## ***Interactive comment on “Beyond the bucket – Developing a global gradient-based groundwater model (G<sup>3</sup>M v1.0) for a global hydrological model from scratch” by Robert Reinecke et al.***

**Robert Reinecke et al.**

Received and published: 24 July 2018

Fig. 1. revised figure 1

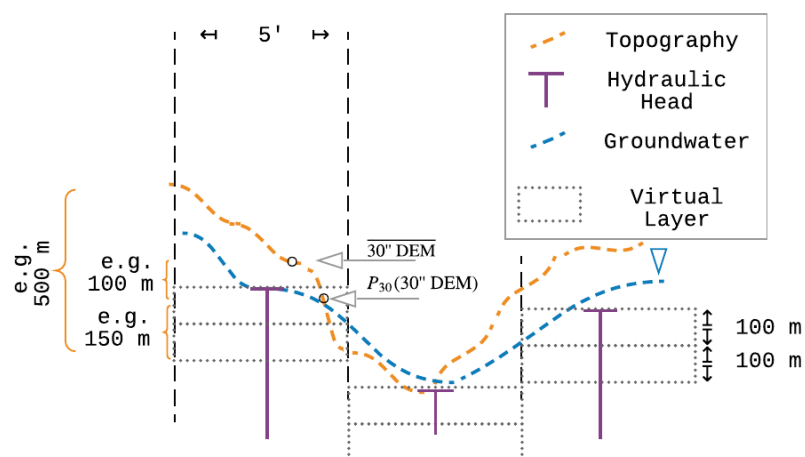
#2.4 The diagram for how the model handles topographic breaks (Fig 1) is super confusing. Basically is water moved between cells even if there is a disconnect?

Reply: Yes, this is due to the coarse lateral discretization where in a  $5'$  grid cell with approx.  $80 \text{ km}^2$  area, the elevation differences can be larger than  $200 \text{ m}$  (as described in the text). Lateral interaction between neighbouring cells is always calculated in the model even if large topographic breaks are present. In order to avoid confusion, we modified Fig. 1 and text in section 2.1 to clarify that the top layer in the model should not be thought of as being located right at the land surface elevation.

Changes to manuscript: To clarify the difficult but important aspect of the relation between model layers and surface elevation in steep terrain at the spatial resolution of  $5'$ , we revised Figure 1 and added to section 2.1: "In addition, due to the coarse spatial scale and the possible large variations of land surface elevations within each grid cell, the upper model layers should not be considered to aligned with an average land surface elevation. The model layers can be rather thought to be vertically aligned with the elevation of the surface water body table, as this prescribed elevation is, together with the sea level, the only elevation included in the groundwater flow equation (Eq. 2)."
